ECE/TRANS/XXX

Addendum

Global technical regulation No. YYY

TECHNICAL REQUIREMENTS ~~for~~*REGARDING*
~~AUDIBLE VEHICLE ALERTING SYSTEMS FOR~~*QUIET ROAD TRANSPORT VEHICLES* ~~with~~
regard to the sound emissions.

Diagram C:

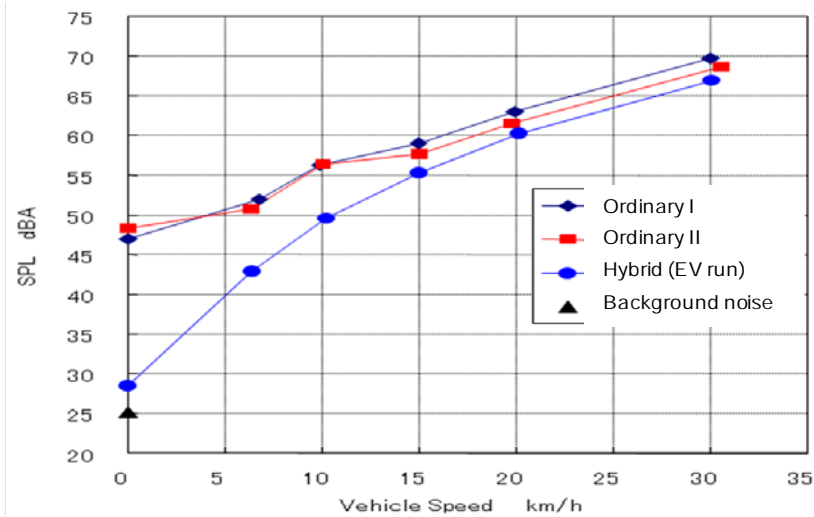
Japan may wish to update this chart
